CUSTOMER NOTIFICATION	ZUD-CD-07-0007 (1/25)
	1月 16, 2007
	团队经理 工具开发部 多用途微处理器部 第4系统操作单位 NEC电子公司

QB-MINI2

使用前需知

Figure 6-11 in **6.2.5 Securing of user resources and setting of security ID ...** (p. 146)

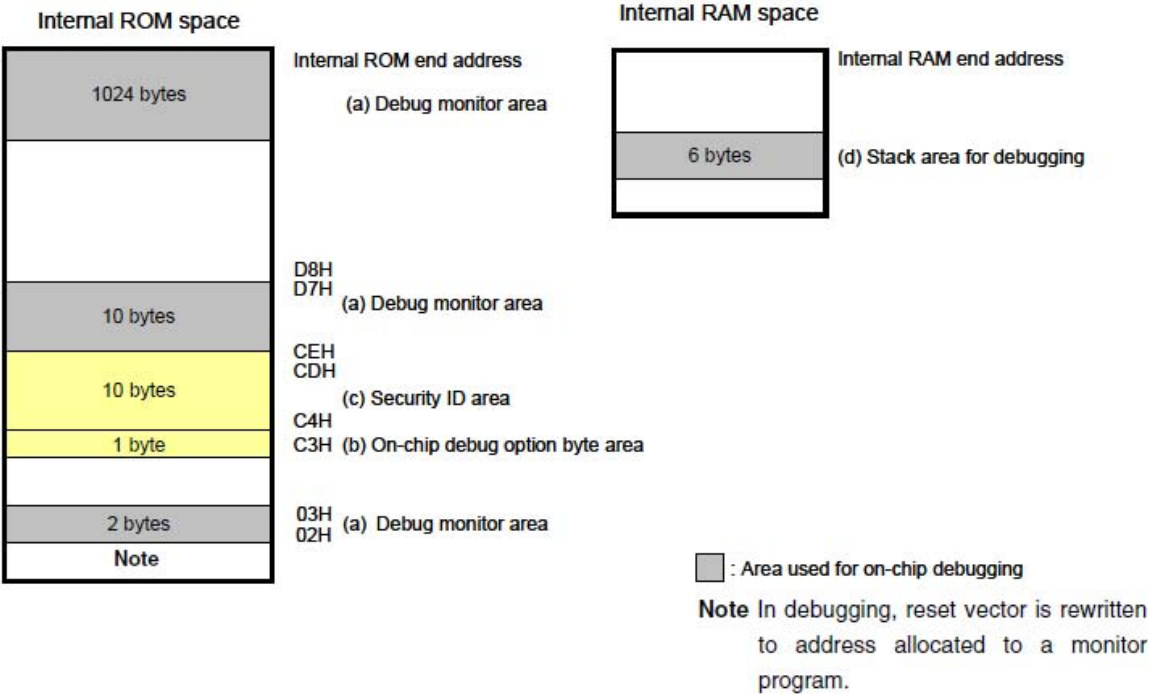
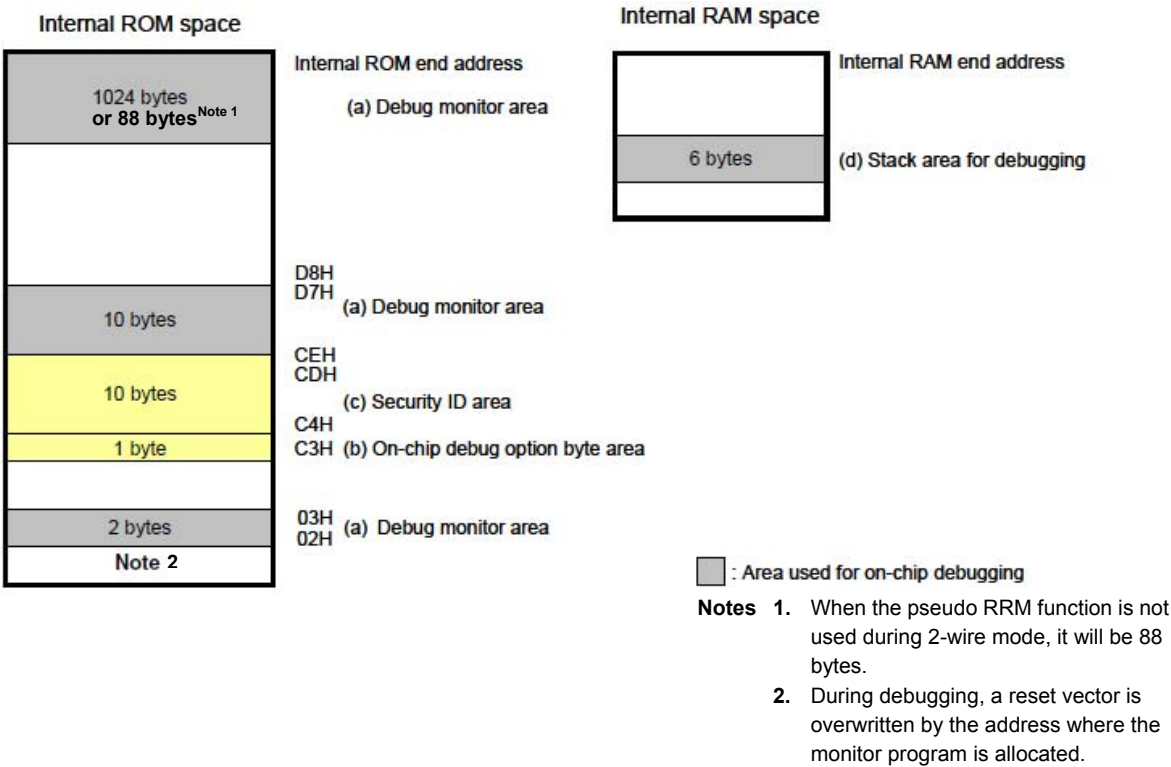
5.2 Reduction of monitor program occupation size in 2-wire mode (78K0R)

➤ After change (addition of **Note 1**)

Note It is an area of 88 bytes when the pseudo RRM function is not used during debugging in 2-wire mode. If the internal ROM end address is 0x3FFFF, a monitor program of 88 bytes is allocated to the area from 0x3FFA8 to 0x3FFFF.
